PLANS AND DOCUMENTS
referred to in the PDA
DEVELOPMENT APPROVAL

Approval no: DEV2022/1329

Subject: Addendum to the bushfire assessment for Carseldine Village

Land and Environment Consultants Pty Ltd (**LEC**) prepared a bushfire assessment and management plan and bushfire attack level (**BAL**) contour plan for Carseldine Village at 532 Beams Road, Carseldine (**the site**), properly described as lot 322/SP172124.

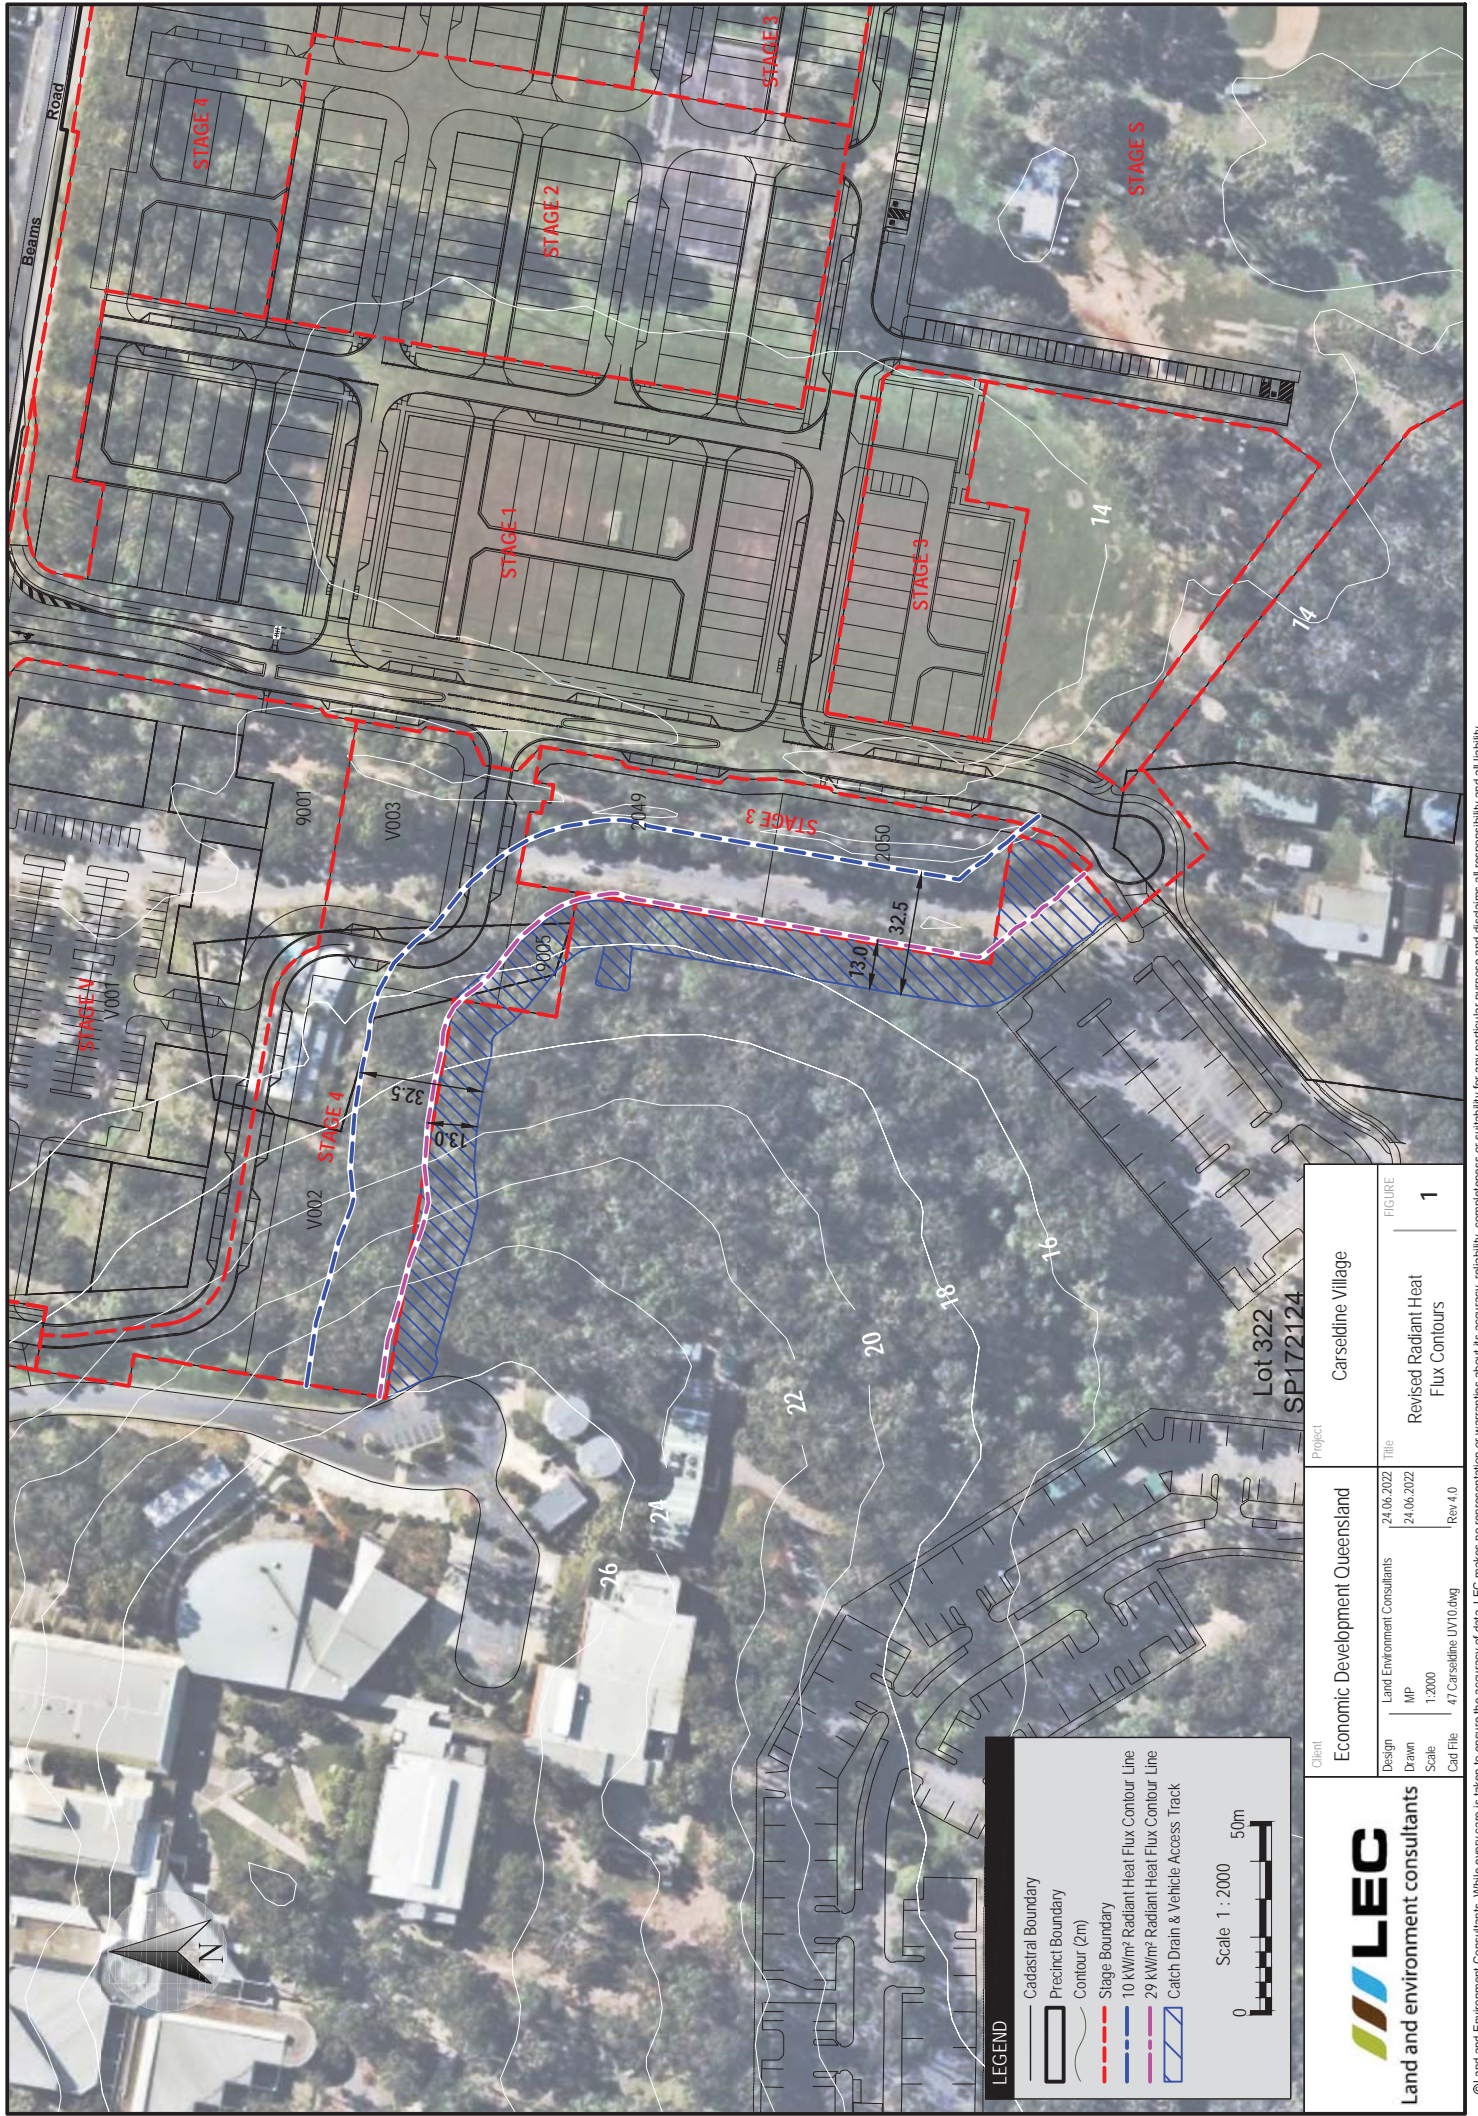
The stormwater drainage swale will be designed and maintained to provide a low fuel hazard area and separation for new buildings within lots 2049, 2050 and V002 from the adjacent bushfire hazard area. On this basis, the revised location of the 10 kW/m^2 and 29 kW/m^2 radiant heat flux contours in relation to lots 2049, 2050 and V002 is shown in Figure 1.

Figure 1 demonstrates that future site planning within lots 2049, 2050 and V002 is no longer constrained by the 29 kW/m² radiant heat flux contour (with the exception of a minor intrusion into the rear boundary of lot V002).

Client		Economic Development Queensland		Project		Carlseldine Village	
Design	MP	24.06.2022	Title	24.06.2022	FIGURE	2	
Drawn	Scale	1:2500	MP	24.06.2022	Revised BAL contours		
Cad File	47 Carlseldine LV10.dwg	Rev 4.0

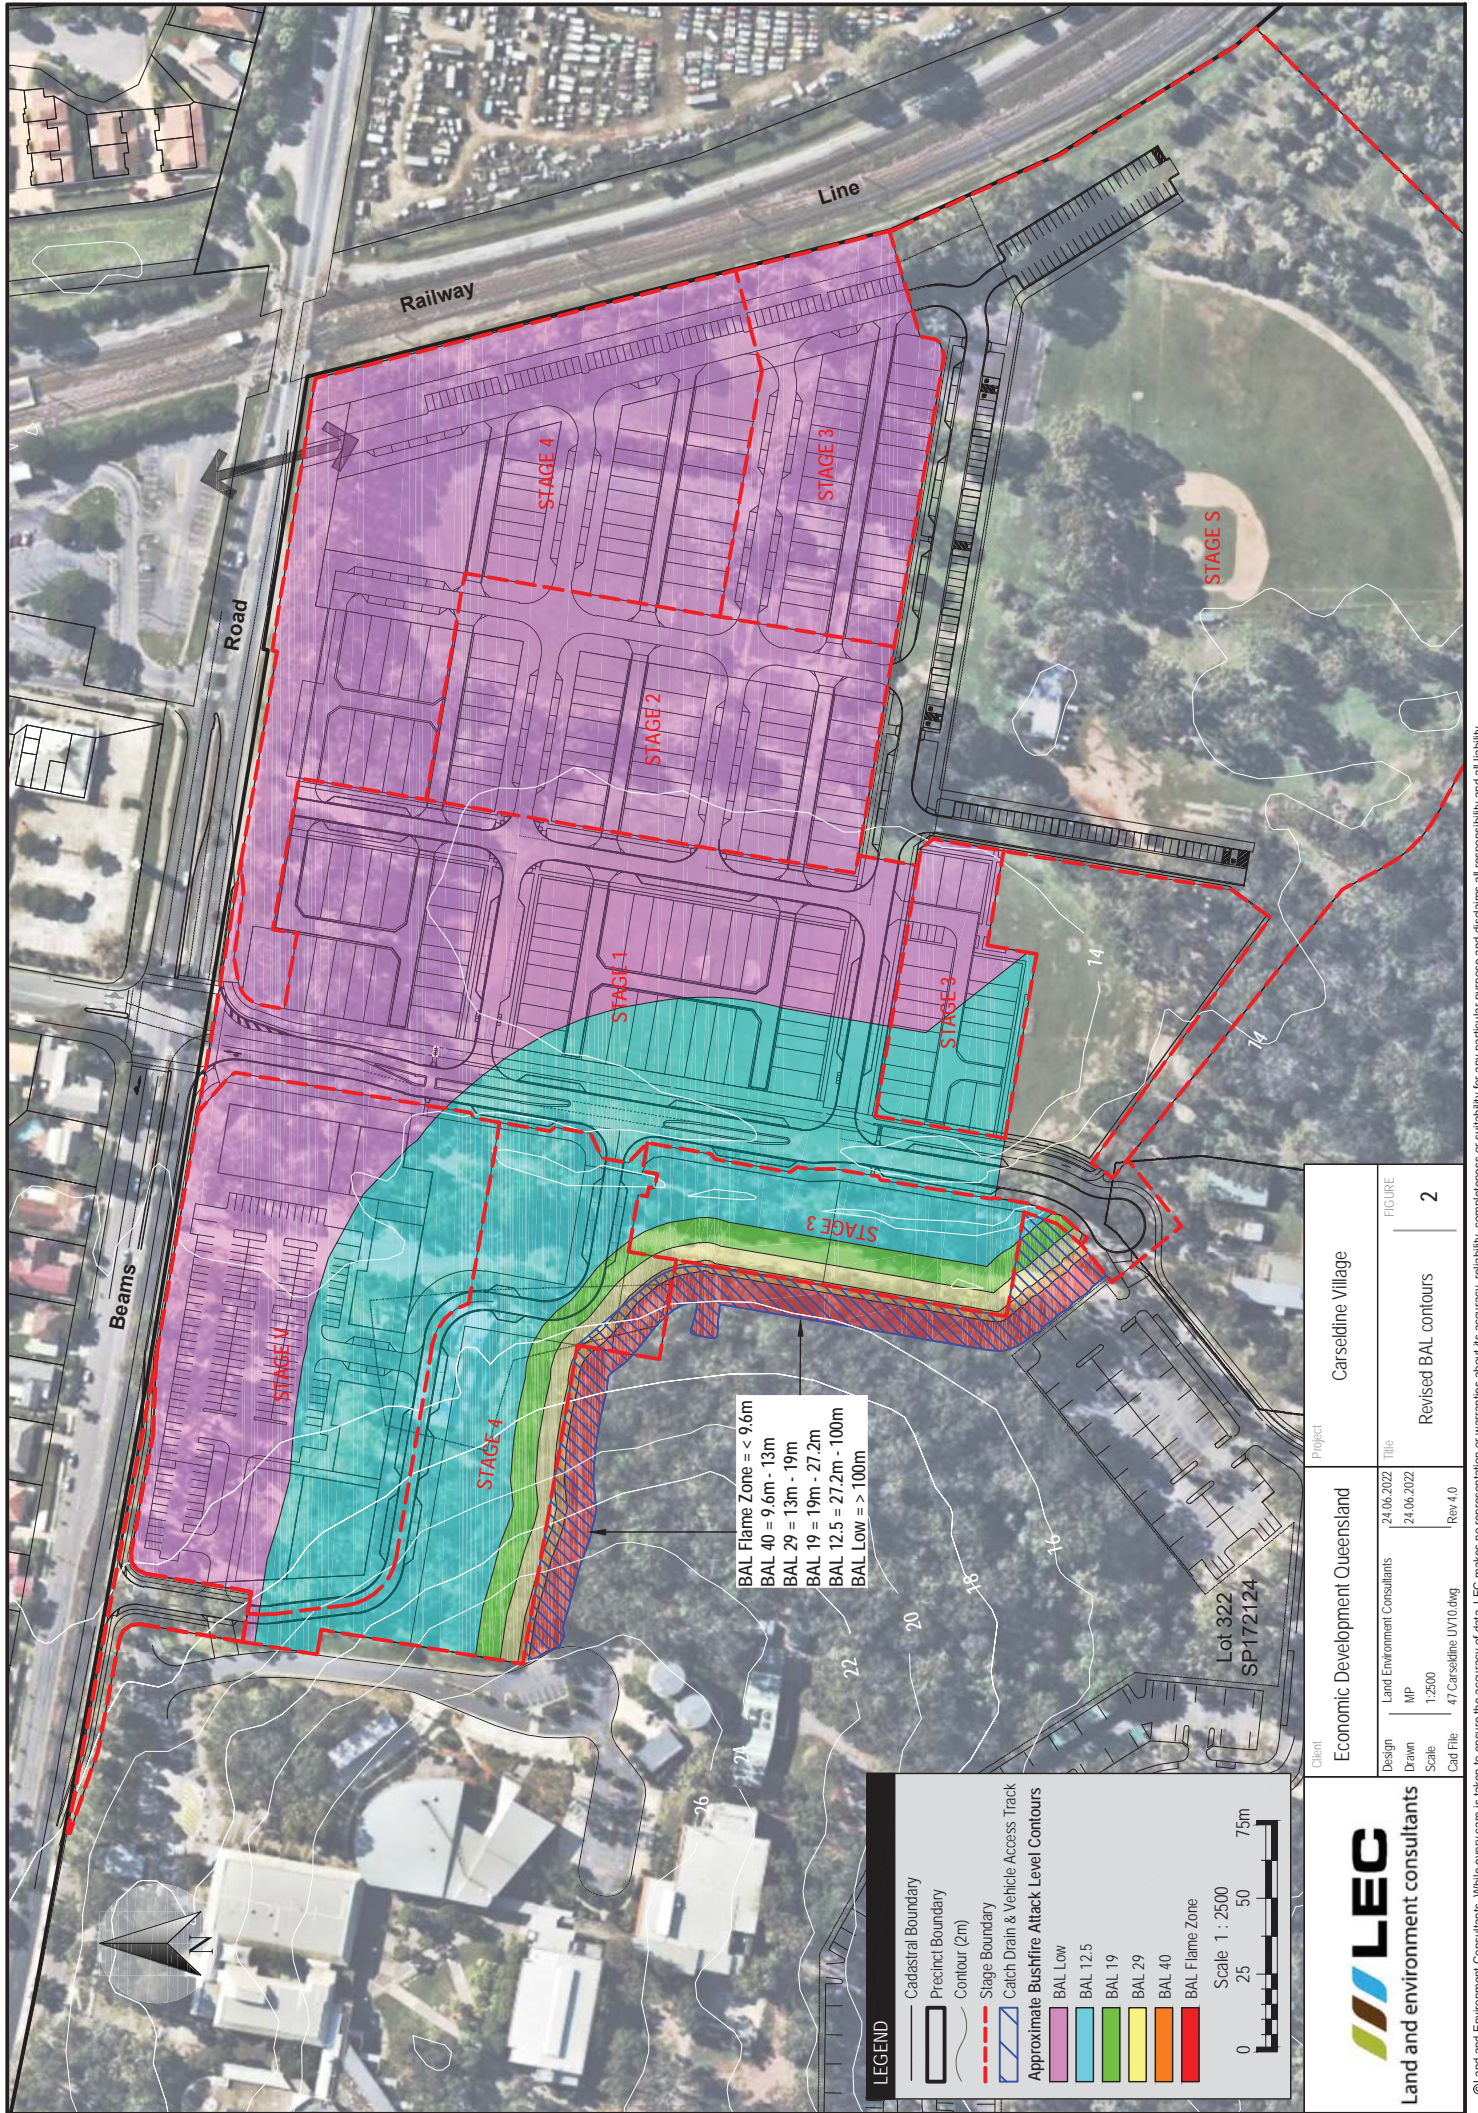
The revised alignment of BAL contours over stages 1-4 and V of Carseldine Village are shown in Figure 2.

Drawing Title: GENERAL LAYOUT PLAN		Date: JUN '22
Drawn: RW	Designated: JB	Checked: MS
Scale: AS SHOWN	Sheet: 02 of xx	Revision: A
Drawing No: A1		22-106-03

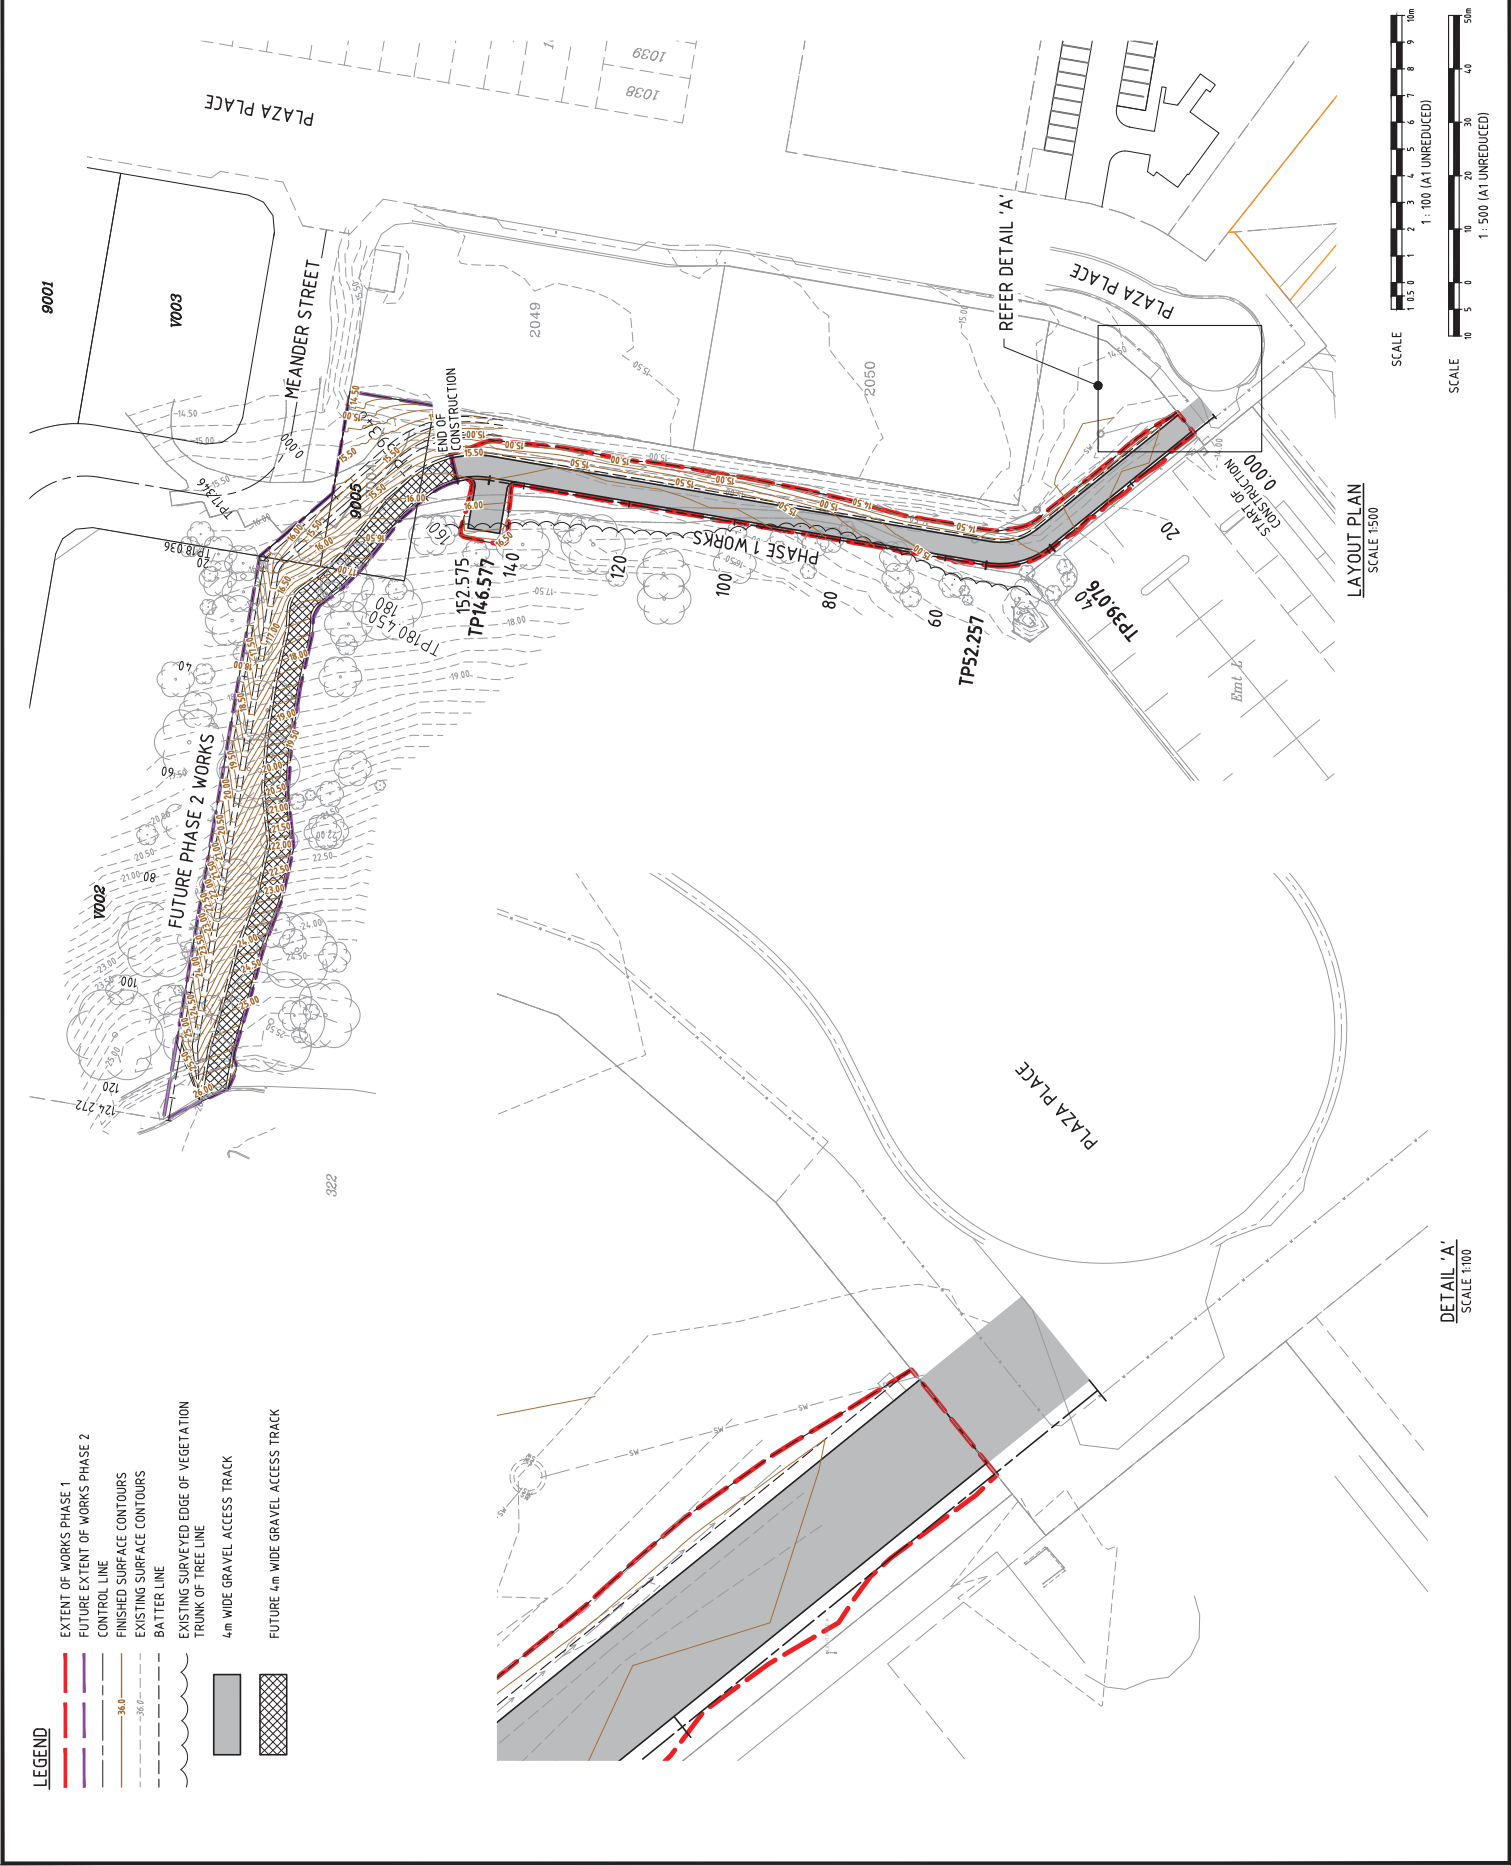
Economic Development Queensland (EDQ) are proposing improvements to the approved reconfiguration of lot plan which include a stormwater drainage swale and restricted vehicle access track behind lots 2049, 2050 and V002 as shown in the draft catch drain plan at Appendix 1. These operational works will be delivered in two phases with Phase 1 being aligned with the rear boundaries of lots 2049 and 2050 and Phase 2 extending through lot 9005 (formerly lot V004) and along the rear boundary of lot V002.

Phase 1 of the restricted vehicle access track is aligned with the rear boundaries of lots 2049 and 2050. It will be 130 m long and will be a dead end track for a temporary period of 9-12 months until Phase 2 works are completed. As a result, the Phase 1 restricted vehicle access track includes a reversing bay/turnaround area which is 6 m wide by 8 m deep.
